1st Further Information

**Proposed Temporary Place of Recreation, Sports or Culture (Hobby Farm and Fishing Ground),
Holiday Camp, Barbecue Site and Animal Boarding Establishment with Ancillary Facilities and
Associated Filling of Land for a Period of 3 Years in "Agriculture" Zone,
Various Lots in D.D.135 and Adjoining Government Land, Pak Nai, Yuen Long, New Territories**

(S.16 Planning Application No. A/YL-PN/91)

Responses-to-Comments

Figure 4 – The Proposed Extent of Natural Terrain Hazard Study

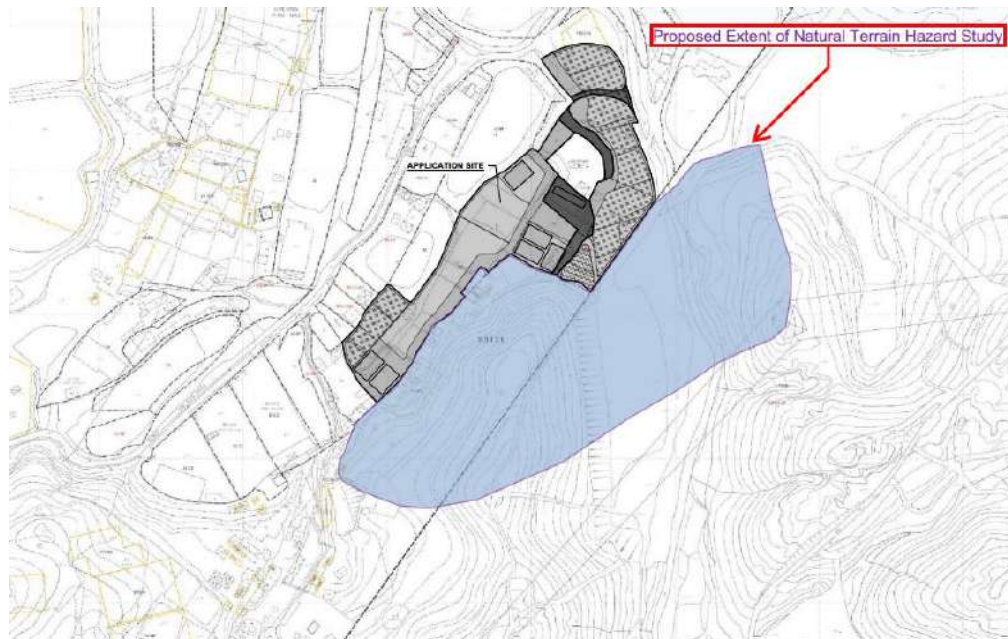
(a)	The subject site is overlooked by steep natural terrain and meets the alert criteria for a natural terrain hazard study (NTHS). The applicant is required to submit a GPRR in support of the Planning Application. The content of the GPRR submitted is noted. However, no content related to natural terrain hazard is incorporated in the GPRR.	Noted. Section 7 is provided in the report to discuss on the natural terrain hazard study (NTHS). Please refer to the revised Geotechnical Planning Review Report for details (Annex I).

(b)	The GPRR should include a preliminary geotechnical review of the natural terrain hazards, assess the geotechnical feasibility of the proposed development, and where necessary, indicate the recommended extent of the NTHS study area and a commitment to undertake the NTHS and to carry out any necessary mitigation measures as part of the proposed development. Other essential contents of a GPRR are given in the attached GEO Advice Note (Annex 1).	Noted. The recommended extent of the NTHS area is suggested in the Section 7. NTHS would be conducted and to carry out any necessary mitigation measures as part of the proposed development.

(c)	Given the temporary nature and the proposed use of the subject site, the requirement for NTHS might make the case not economically viable. As an alternative, part of the subject site may be designate as a “no-build” zone (Annex 2). No critical facilities (Group 1 to 3 facilities as stated in Annex 3) should be located within the no-build zone. In particular, the proposed structure B3, B4 and B5 should be located away from the “no build” zone. With the inclusion of the “no-build” zone, the requirement for NTHS may be waived.	The recommended extent of the NTHS area is suggested. NTHS would be conducted and to carry out any necessary mitigation measures as part of the proposed development.
-----	--	--

- 7.1 There is no natural terrain within the subject Site. The natural terrain is located at the Southeast side of the Site. Nature terrain hazard study would be conducted and to carry out any necessary mitigation measures as part of the proposed development. The proposed extent of natural terrain hazard study is highlighted under Figure 4 below and attached in Appendix H. However, the actual extent will be subjected to final layout and activity zone of the academy
